LAST REVISION	REVISION	DESCRIPTION:			INDEX	SHEET
11/01/17			FDOT FY 2023-24 STANDARD PLANS	BRIDGE FENCING (OVER RAILROAD)	550-013	1 of 3

TYPICAL SECTION
ON TRAFFIC
RAILING BARRIER

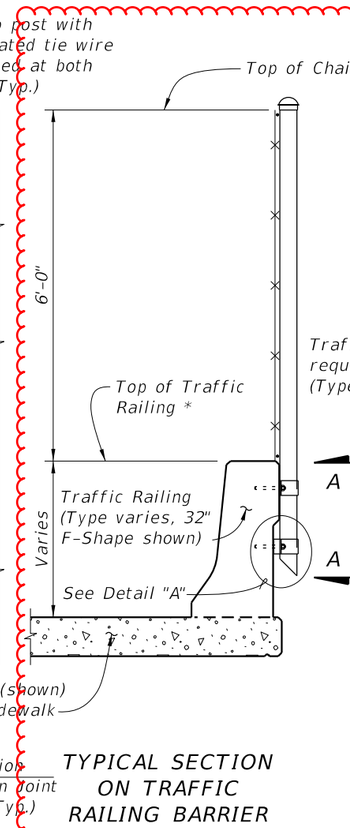
* Fencing shall not anchor to the top of Traffic Railings.

Corrected Typical Section
